TENNESSEE VALLEY AUTHORITY

TVA SQN TS 60

By the October 2, 1984 letter from L. M. Mills to you we submitted a request to amend operating licenses DPR-77 and DPR-79 (TVA-SQN-TS-60) for our Sequoyah Nuclear Plant units 1 and 2 technical specifications. These changes requested improved radiological effluent specifications and altered section 6 of the technical specifications to reflect changes to the organization, the nuclear review and audit group (Nuclear Safety Review Board), and the independent safety engineering group.

This letter revises our October 2 submittal to reflect the recent organizational changes made as part of TVA's Nuclear Performance Plan. By this letter we formally withdraw the proposed changes to the nuclear review and audit group. We will no longer establish a Nuclear Safety Staff, but will retain the existing Nuclear Safety Review Board format. These proposed changes are provided in the enclosure. NSRB review is being performed concurrent with your review.

Figure 6.2-2
Facility Organization

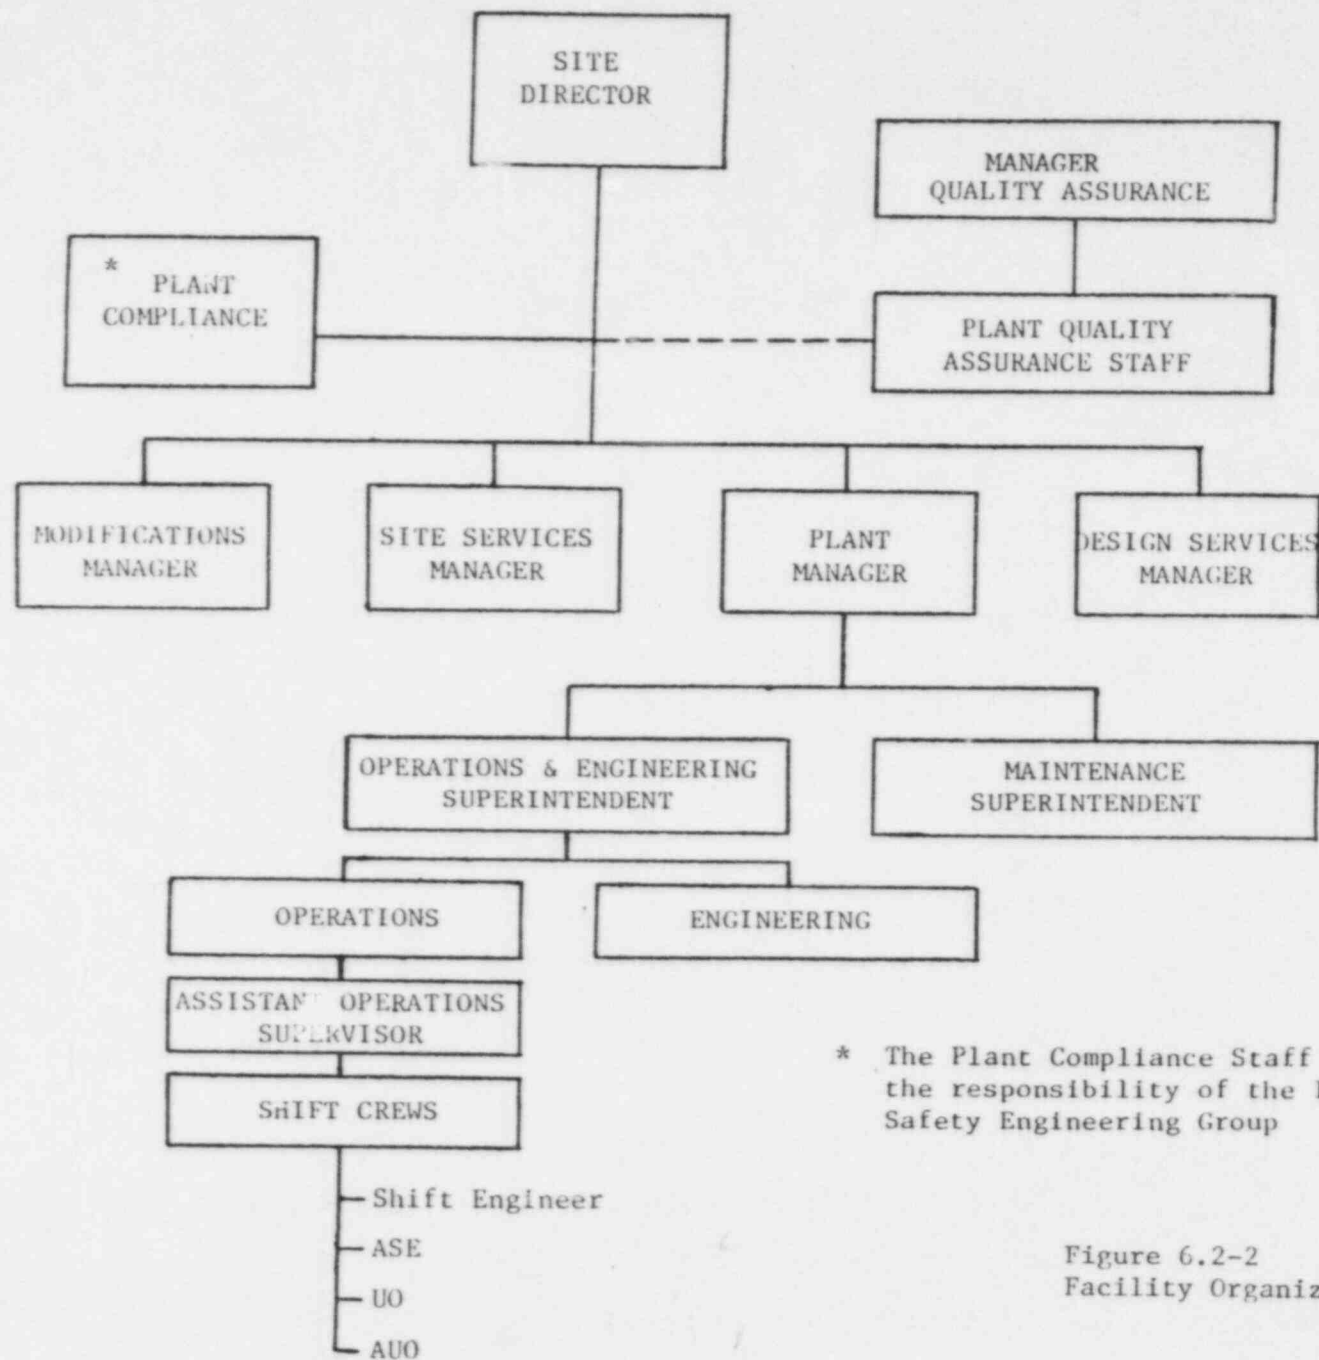
* The Plant Compliance Staff fulfills the responsibility of the Independent Safety Engineering Group
